CITY OF CONWAY, ARKANSAS
HISTORIC DISTRICT COMMISSION

March 30, 2026

A. 1511 Caldwell St (HDR-0326-0027) Exterior Repair & Replacement

B. 1709 Prince St (HDR-0326-0030) Enclosed Porch Addition

1 SITE PLAN
1/8" = 1'-0"

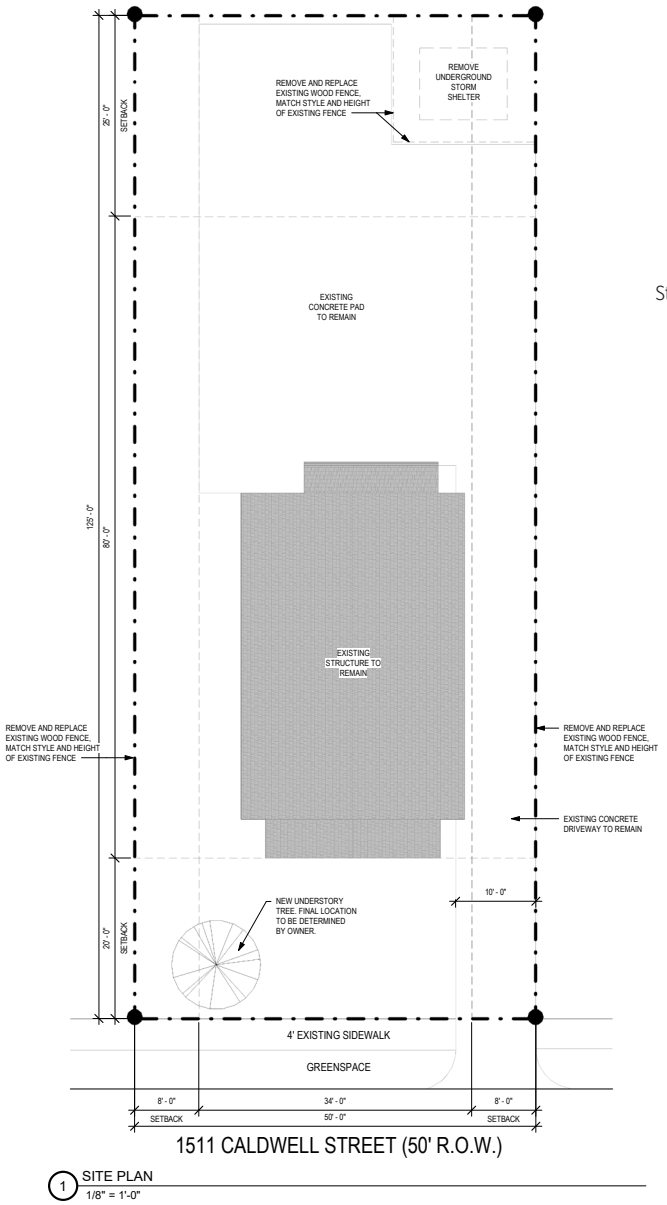
1. Applicant must obtain all applicable building permits* if/when a Certificate of Appropriateness is granted. This includes a demolition permit for the storm shelter.

Storm shelter to be removed

ADCOCK RESIDENCE REMODEL
EXTERIOR ELEVATIONS

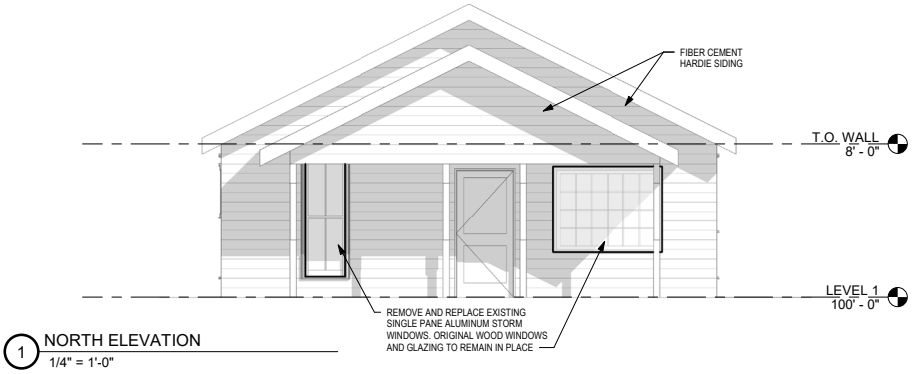
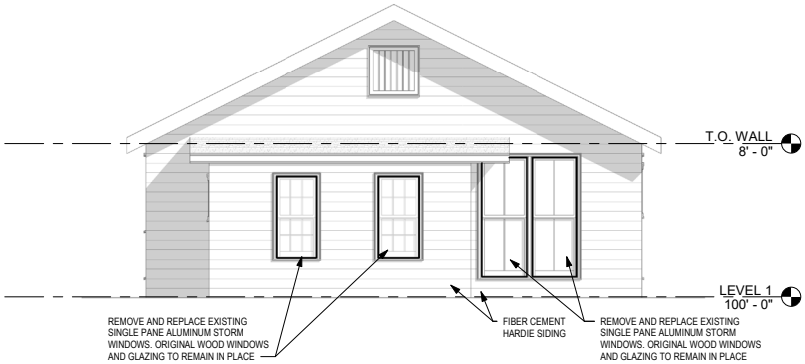
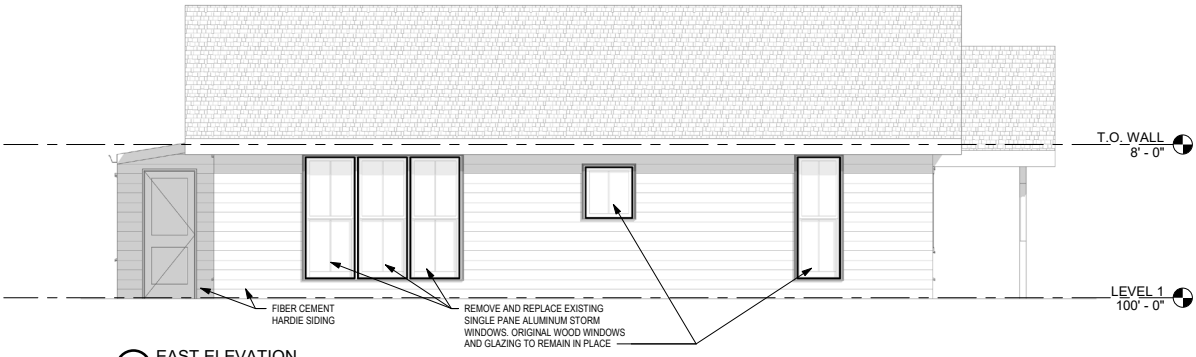
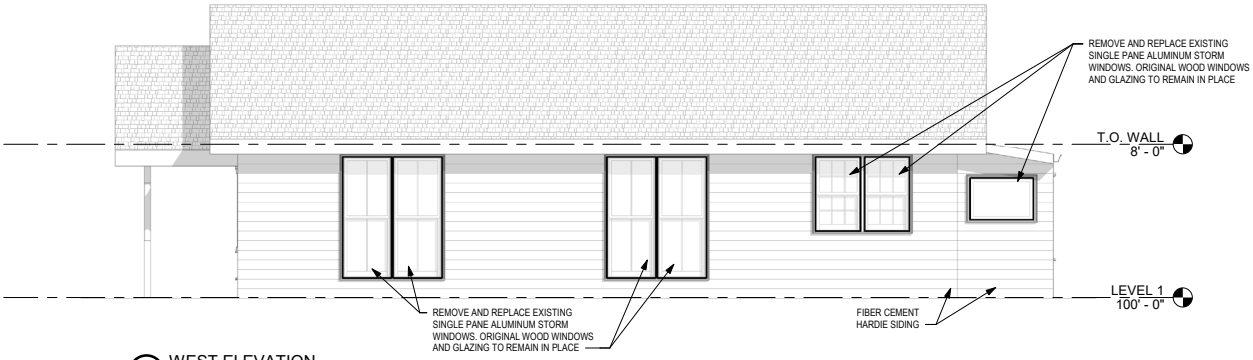
Repair historic windows and doors and their distinctive features through recognized preservation methods for patching, consolidating, splicing and reinforcing. If desired, introduce narrow-profile exterior or interior storm windows so that they do not obscure or damage the existing sash and frame. Select exterior storm windows with a painted or baked-enamel finish color that is compatible with the sash color. For double-hung windows, operable storm window dividers should align with the existing meeting rail.
Currently, the windows are inoperable and slightly obscured by aluminum storm windows. The applicant would like to restore the existing windows to make them operable. The sash is white and the replacement storm windows will have a white finish color.

Existing storm windows

Proposed storm windows

2. Siding shall be composed of wood or a wood-like material such as Hardie ® siding/LP® SmartSide ®.
3. Existing windows shall be retained and preserved.
4. Operable storm window dividers should align with the existing meeting rail.
5. Storm windows shall have a painted or baked-enamel finish color that is compatible with the sash color.

SOUTH ELEVATION
1/4"=1'-0"
New Roof Line For Screened Porch
Screen Door
Screen Section
18'
10'
T.O.
Tree Does Not Exist Anymore!
EAST ELEVATION
1/4"=1'-0"
Screen Door
Shed Style Roof
Roof Line
Valley
WEST ELEVATION
1/4"=1'-0"

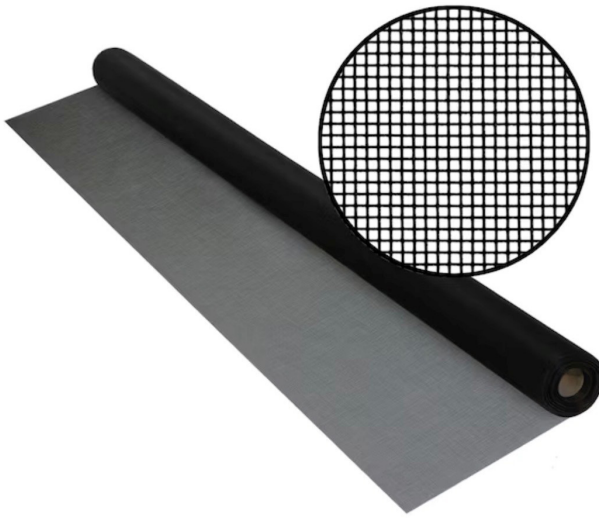
The applicant is proposing to extend the roofline over the back porch and enclose it. The footprint of the house will not change.

Additions. Construct new additions so that there is the least possible loss of historic fabric and so that the character-defining features of the historic building are no destroyed, damaged or obscured.
The roofline is being extended to accommodate the screened in portion of the porch. The railing, walls, and other character-defining features will be retained. The rear of the house will be slightly obscured by the screened in portion of the porch.

Limit the size and scale of an addition in relationship to the historic building so that it does not diminish or visually overpower the building.
The deck is existing and is being rebuilt. The size and scale of the addition will not overpower the residence. The residence is 2,187sf and the addition is 288sf.

Design an addition to be compatible with the historic building in mass, materials, color and relationship of solids to voids in the exterior walls, yet make the addition discernible from the original.
The addition is compatible with the historic building in all of the above excluding the screening material. The roofline and beams are compatible.

The addition shall be constructed in such a manner that if removed in the future, the essential form of the historic structure would be unimpaired.
The screened portion of the porch could be Removed and will have its own roof line.

Windows & Doors. If desired, introduce full-light storm doors constructed of wood or aluminum that do not obscure or damage the existing door and frame. Select storm doors with a painted, stained, or baked-enamel finish color.
Proposed storm doors will be installed as access points for the porch and will not affect existing doors or architectural features.

2. Roofing materials shall match existing structure.
3. If the existing sidewalk is damaged during construction, it must be repaired.
4. Lighting shall be inward, downward, and shrouded to stay within the bounds of the property.
5. Storm doors shall have a painted, stained, or baked-enamel finish color.
6. Support structures (example, beams) must match existing in material type and color.
